DRAINAGE REPORT

SUNSET WEST UNIT 2
ALBUQUERQUE, NEW MEXICO

April 1994

SUNSET WEST UNIT 2
DRAINAGE AREAS
INTERIM I CONDITIONS

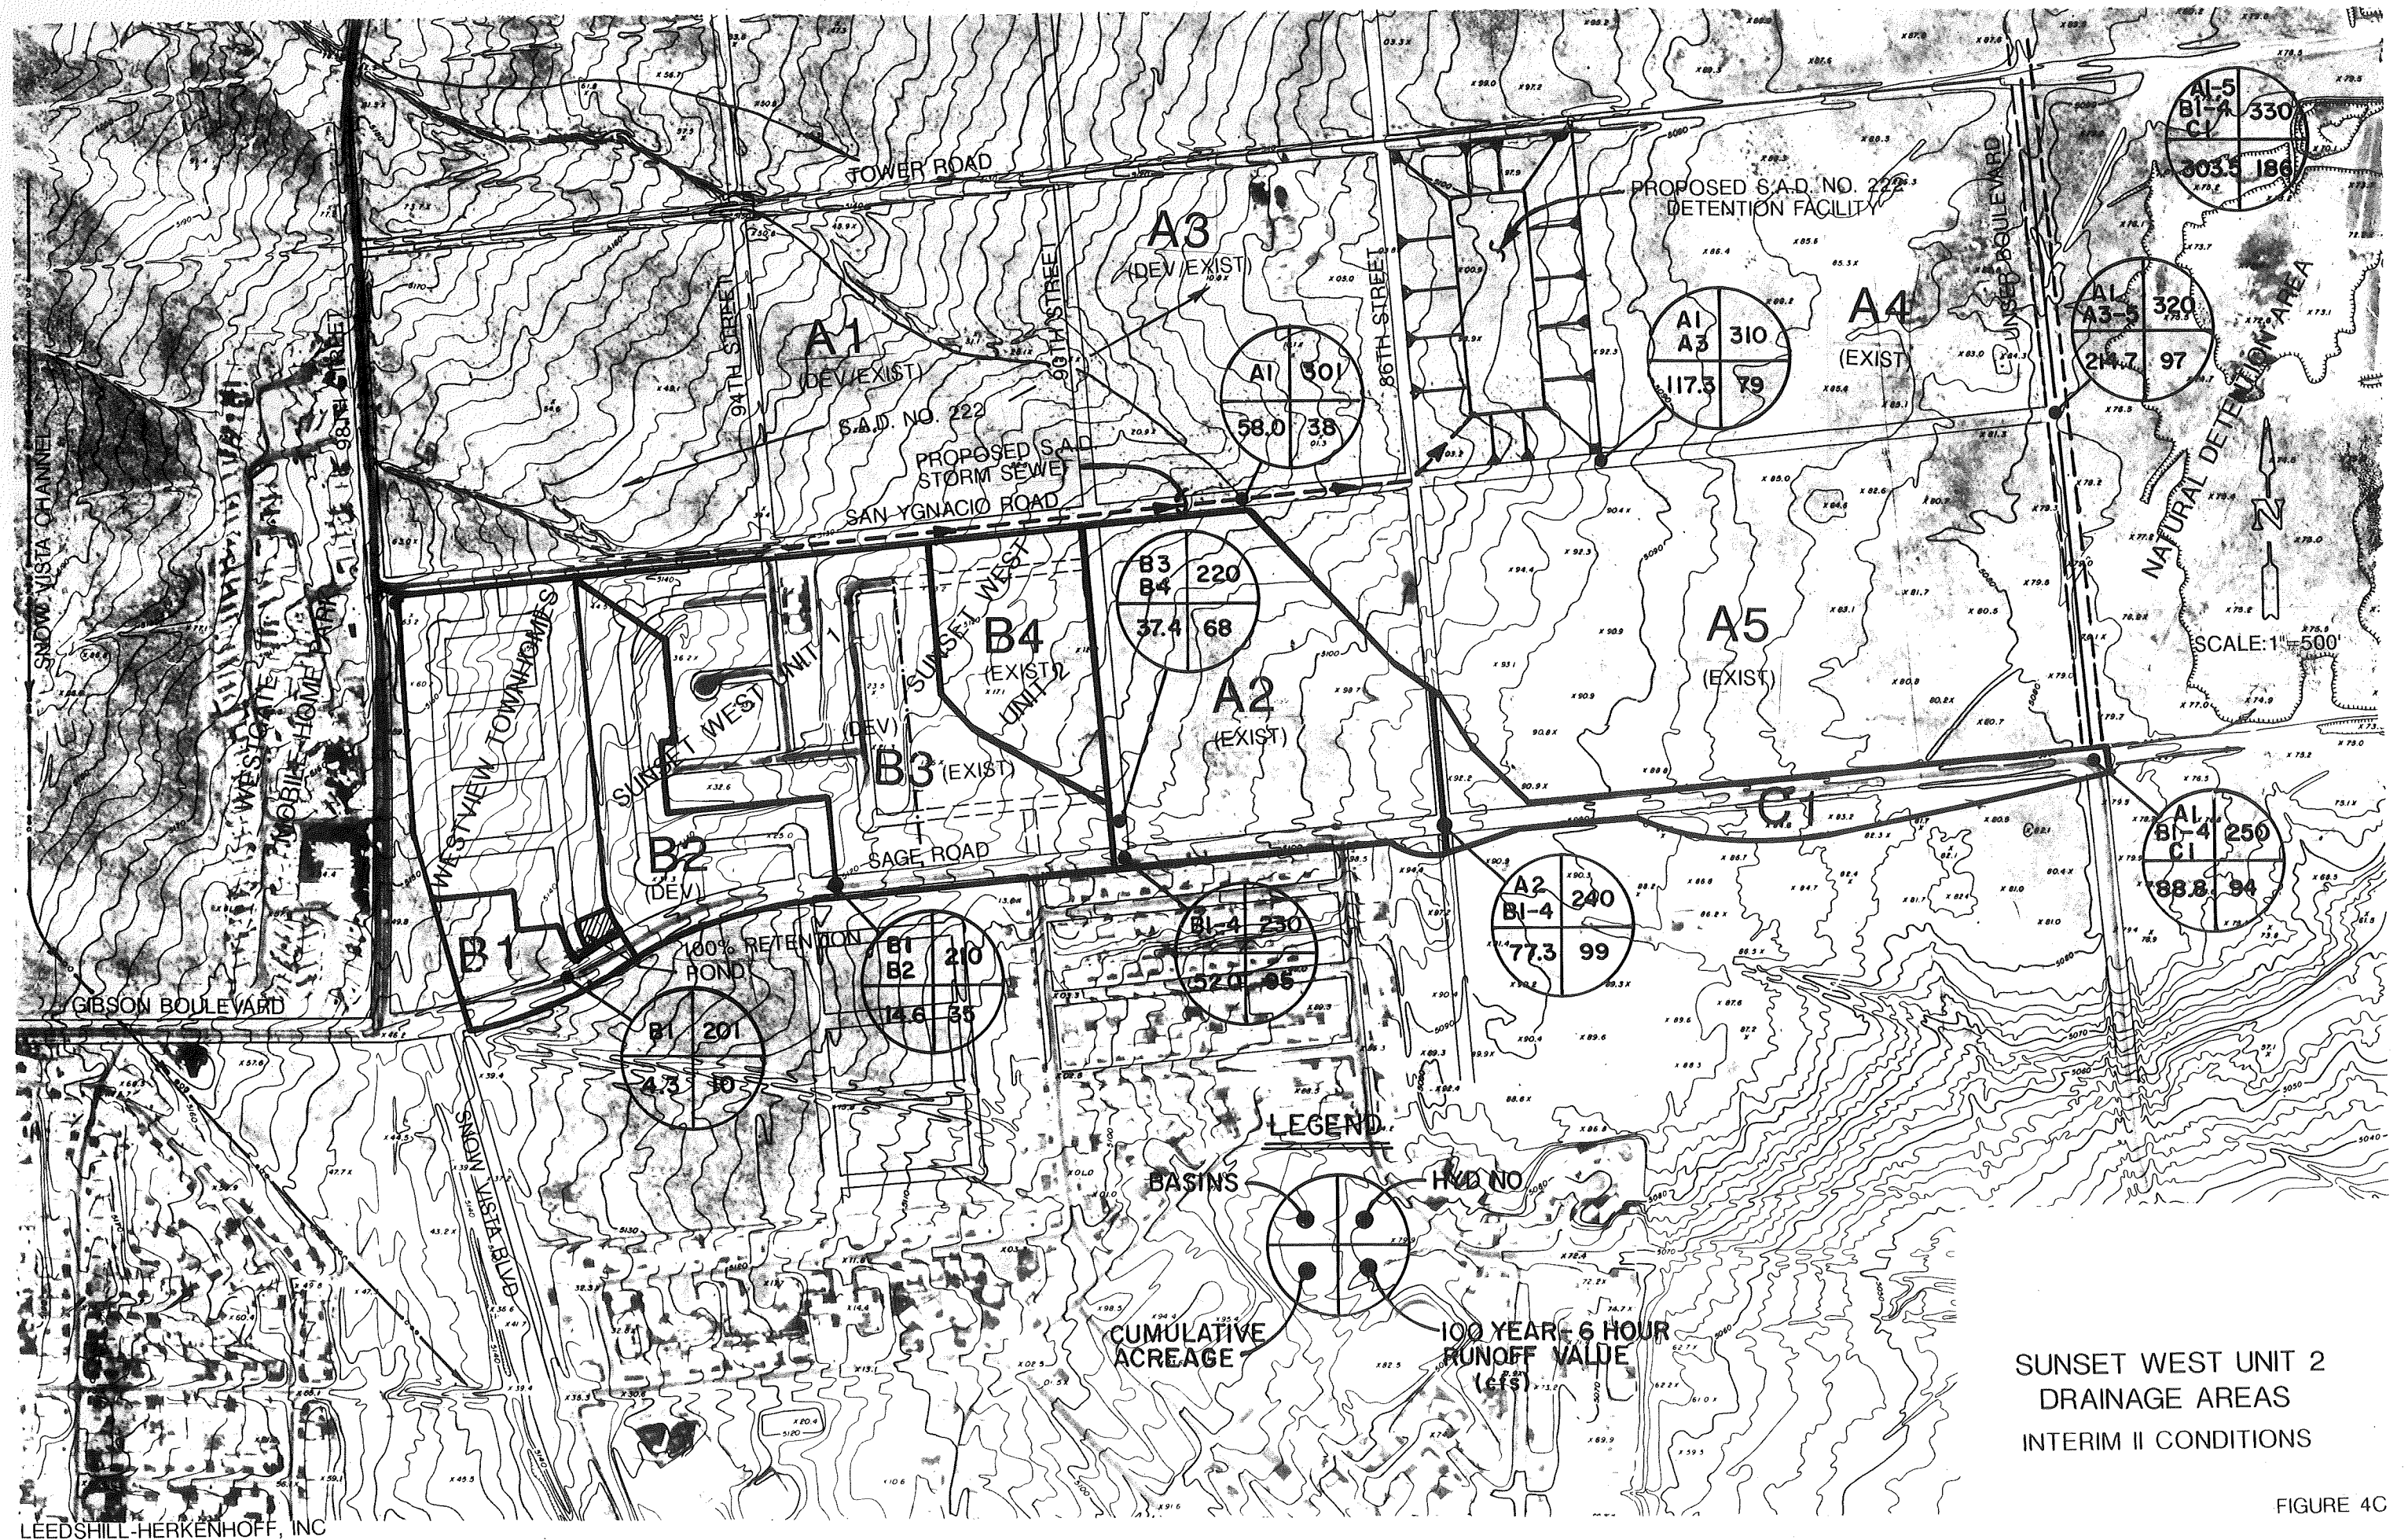
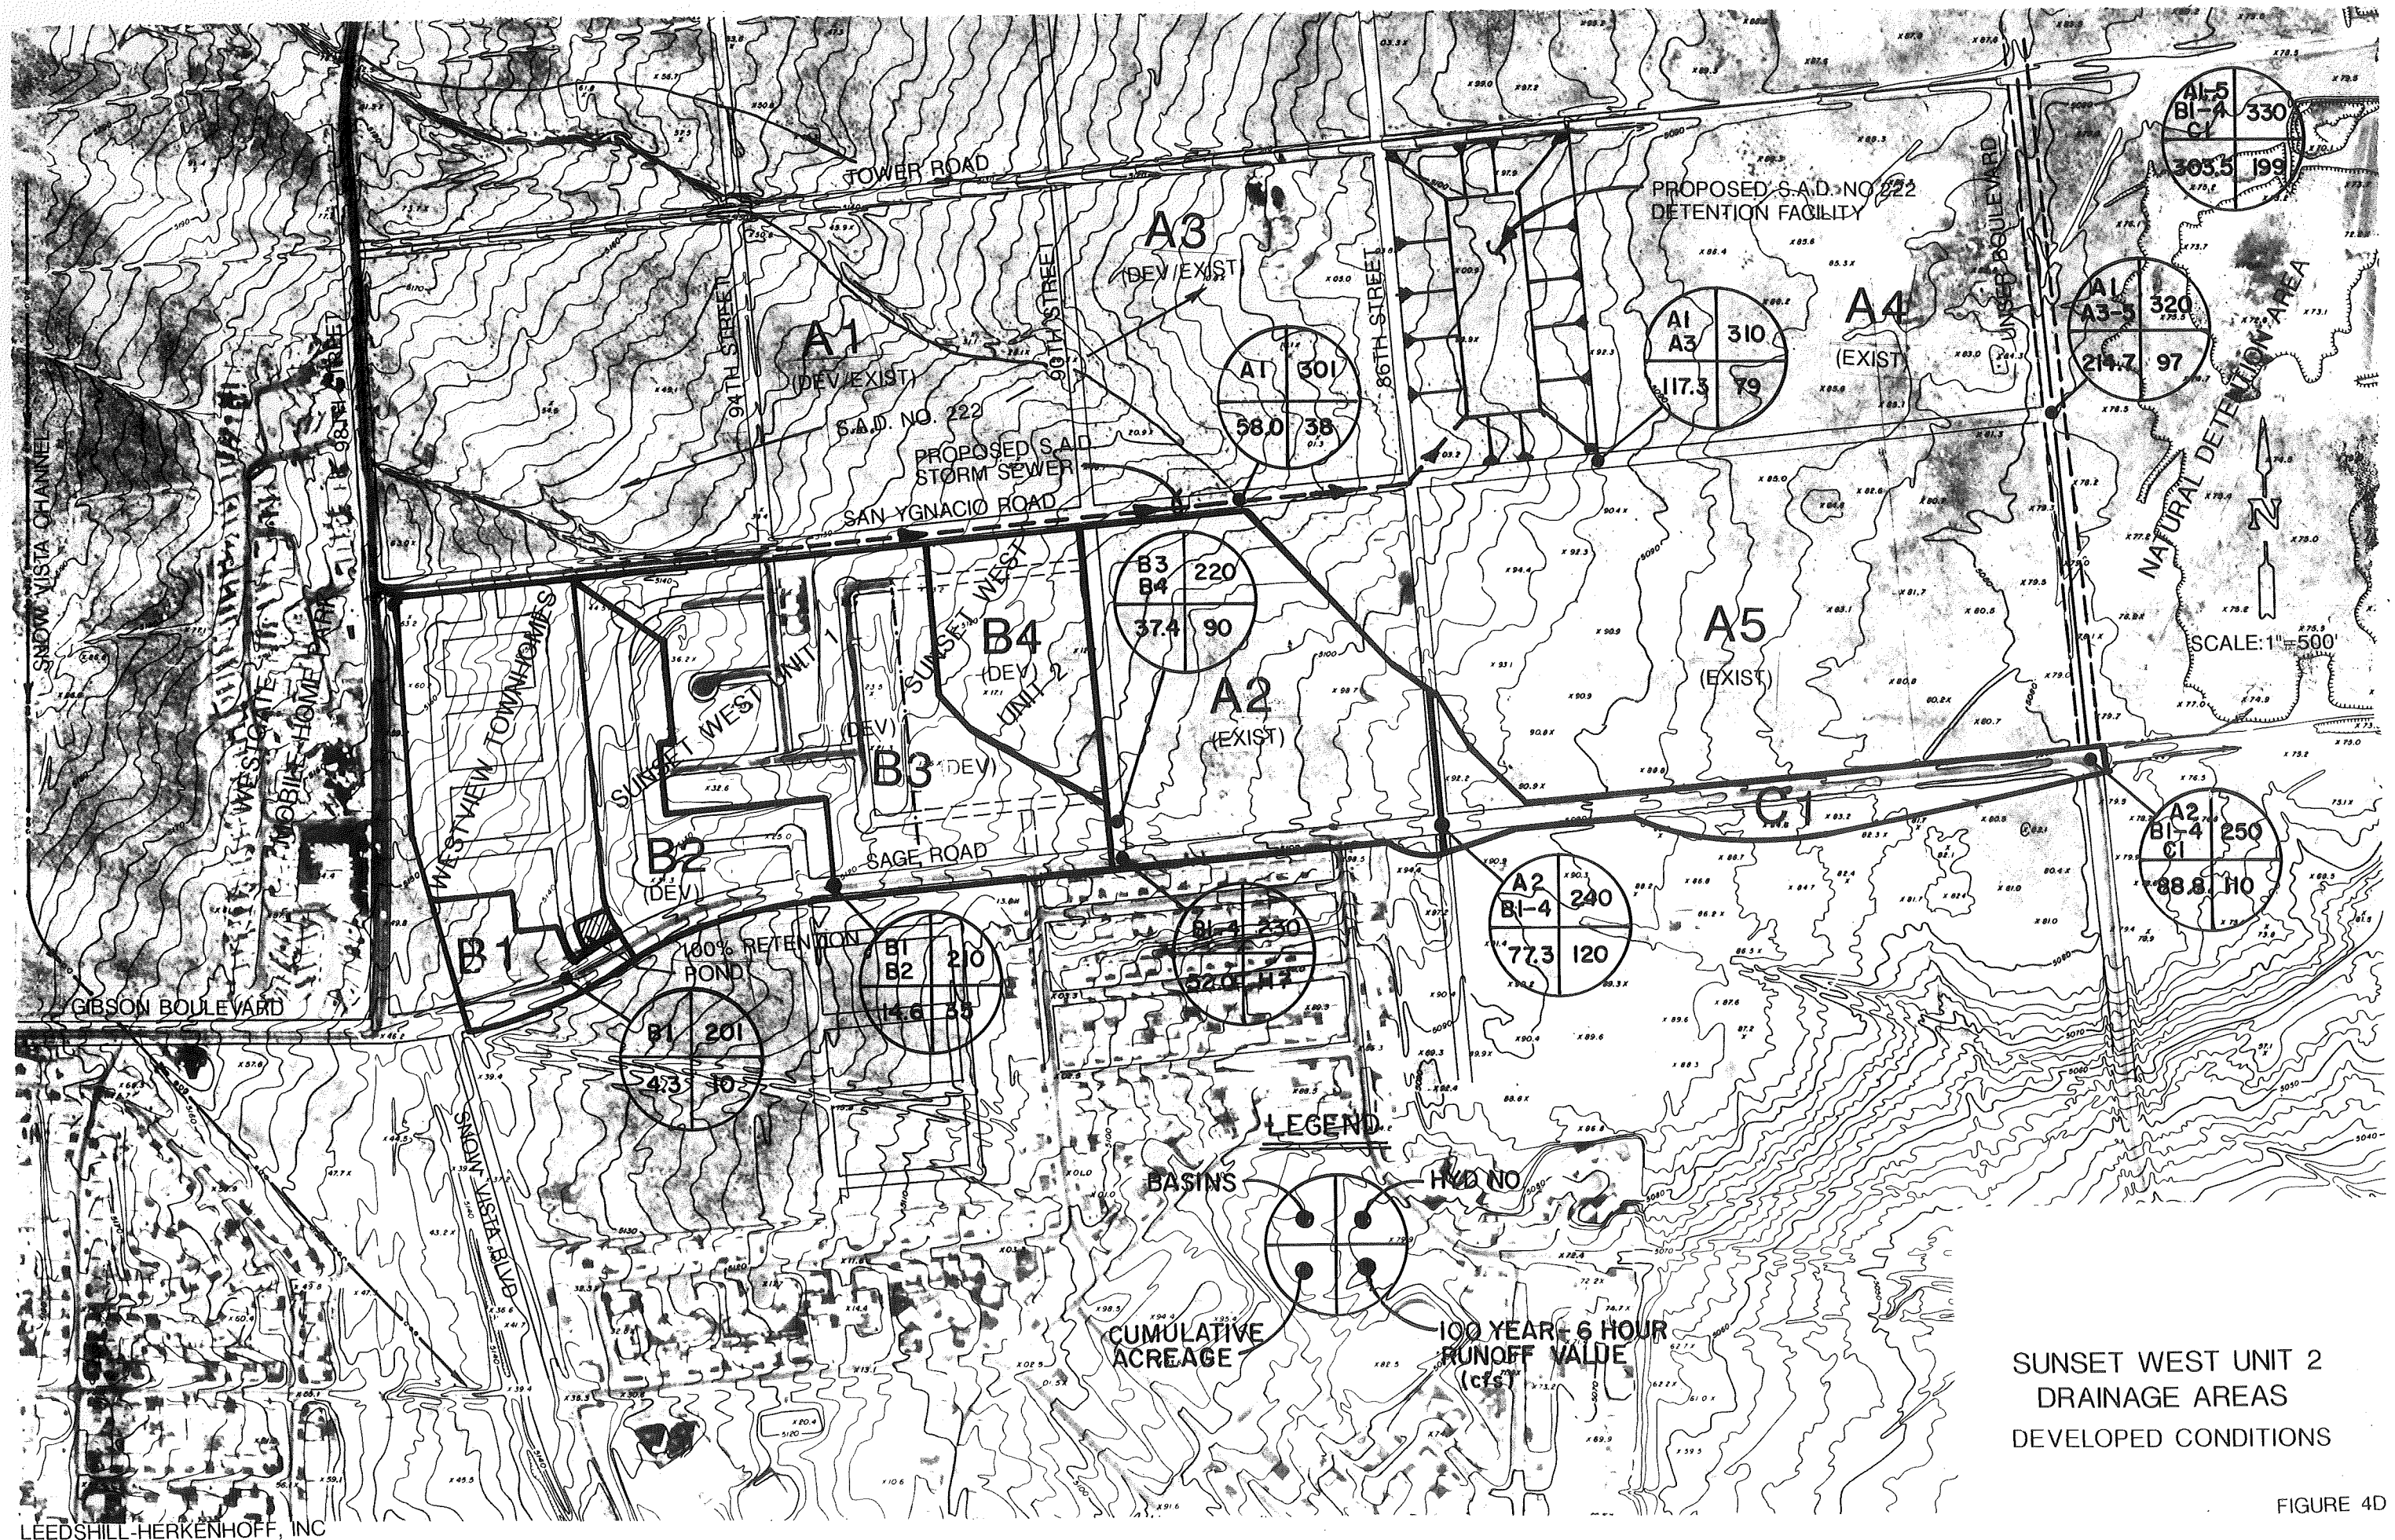
→ they may want to reclaim
